DESIGN	DRAWN BY <i>up</i>	DART AEROSPACE LTD HAWKESBURY, ONTARIO, CANADA	
CHECKED	APPROVED	DRAWING NO. DSI 9262	REV. A SHEET 1 OF 1
DATE 03.05.14		TITLE SKIDTUBE REPAIR	SCALE NTS
A	03.05.14	NEW ISSUE

DART SERVICE INSTRUCTION

TO AMEND D412-673 Rev. A
AND D205-634 Rev. A OR Rev. B
REF. CANADIAN STC: SH96-88
REF. FAA STC: SR000563NY

To repair elongated holes used to attach Bell electric step to Dart D205-634-011 skidtube:

FWD/AFT VIEW OF SKIDTUBE

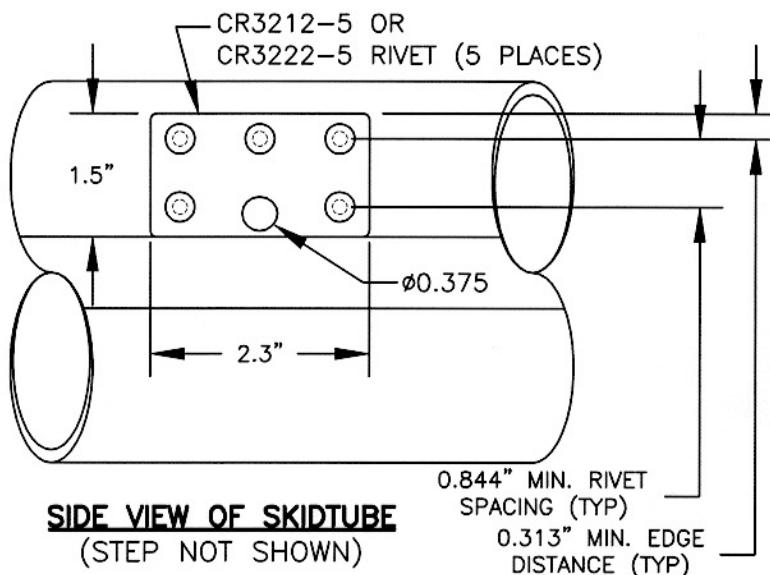
- 1) Temporarily remove (4) bolts that attach electric step to Dart D205-634-011 skidtube.
- 2) Remove (4) ALS7-428-165 inserts.
- 3) Fabricate doublers from 1/4 hard 14 gauge (0.080") AISI 301/302/304/316 stainless steel per MIL-S-5059 as shown below.
- 4) Install over damaged area using CR3212-5 / CR3222-5 rivets and Proseal 890. The location of the doubler (and $\varnothing 0.375$ hole) may have to be adjusted fwd/aft to allow for fitting under the skidtube wearplates.
- 5) Reinstall electric step using hardware shown below. Transfer drill $\varnothing 0.375$ through web.

AN6-53 BOLT (1)
AN960JD616 WASHER (2)
AN310-6 NUT (1)
MS24665-285 COTTER PIN (1)
